Access Compliance Report

Public Rights-of-Way

Intersection ID: 10019976	Main Street: ARENA_BV	Cross Street: N/A	Location:	N
ADA ID: 4090B264B60A	Ramp Type: PerpDiag	Initial Pass/Fail: Fail	Overall Compliance: No	Severity Score: 37.5

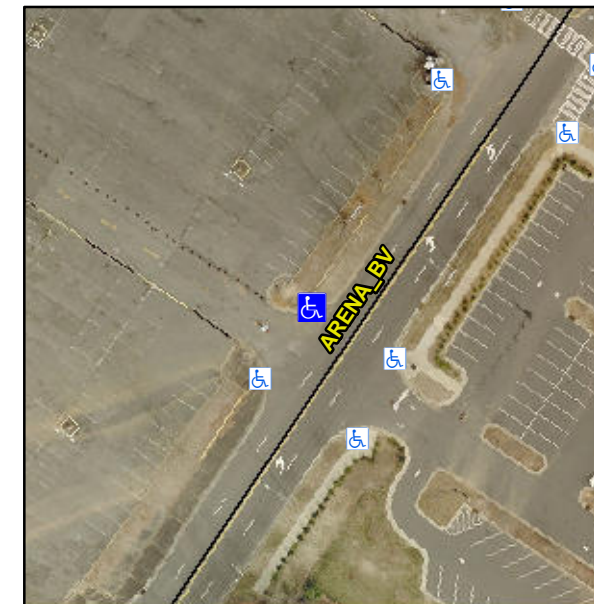
Not Found, R304.2.2, R304.5.3

Compliance	Description	Data	Compliance	Description	Data
N/A	Ramp Length (in)	48.0	No	Ramp Slope (%)	9.5
Yes	Ramp Width (in)	132.0	No	Ramp XSlope (%)	14.9
N/A	Flare Type LT	N/A	N/A	Flare Type RT	N/A
N/A	Flare Slope LT (%)	N/A	N/A	Flare Slope RT (%)	N/A
N/A	Flare Traversable LT?	N/A	N/A	Flare Traversable RT?	N/A
N/A	Landing Length (in)	N/A	N/A	DWS Provided?	N/A
N/A	Landing Width (in)	N/A	N/A	DWS Contrast?	N/A
N/A	Landing Slope (%)	N/A	N/A	DWS Length (in)	N/A
N/A	Landing X Slope (%)	N/A	N/A	DWS Full Width?	N/A
N/A	Landing Curb? (Y/N)	N/A	N/A	DWS Offset (in)	N/A
N/A	Shared Landing?	N/A			
N/A	Gutter Ponding?	N/A	N/A	Gutter Slope (%)	N/A
N/A	Gutter Lip Ht (in)	N/A	N/A	Gutter X Slope (%)	N/A
N/A	Painted X Walk1?	No	N/A	Painted X Walk2?	No
	X Walk 1 Direction	To SW		X Walk 2 Direction	To SE
N/A	X Walk 1 Width (in)	N/A	N/A	X Walk 2 Width (in)	N/A
	X Walk 1 Slope (%)	8.6		X Walk 2 Slope (%)	3.9
	X Walk 1 X Slope (%)	2.5		X Walk 2 X Slope (%)	9.4

Remove & Replace Curb Ramp With Two New Directional Ramps or Equivalent.
